# Cliffbrook Campus Renewal: Community Engagement Summary

# UNSW AGSM Cliffbrook House Redevelopment Community Information Session Report

**Draft** Report  
20/02/2017

18.2 Response to Community Consultation 01

Revised Layout Plans in response to Community Consultation No. 01  
Lower Ground Level

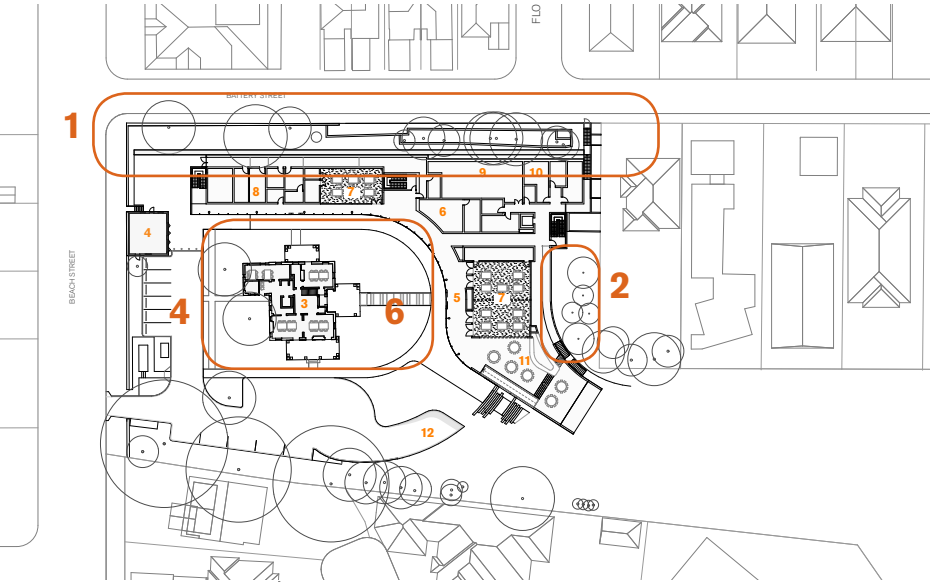
Theme	Concern	Action	
Privacy	Removal of trees along Battery Street Boundary	1	New development set back from the Battery Street northern boundary to retain existing trees to maintain both privacy and views of trees.
	Use of eastern portion of the site	2	Site massing setback to eastern portion to provide a landscaped breathing zone between proposal and #10 Battery Street.
Views	Overall height and urban form of development especially along Battery Street	3	Site strategies developed to carefully locate built form to the north/eastern corner of the site.
Heritage	Importance of heritage items to be considered	4	Development of site strategies carefully considers massing and relationship to heritage fabric by providing an extended curtilledge
Safety	Access to eastern portion of site	5	Consdieration of design of pathway and reflection platforms to eastern portion of site
Traffic and Parking	Overall concerns re increased volumes of parking required and traffic generation	6	Detailed traffic study commissioned and lower ground parking introduced into the scheme.

Acoustics	Noise generated by large recreational area to eastern end of the new building	7	External recreation areas to be used for large gatherings limited to internal courtyard on upper portion of the site.
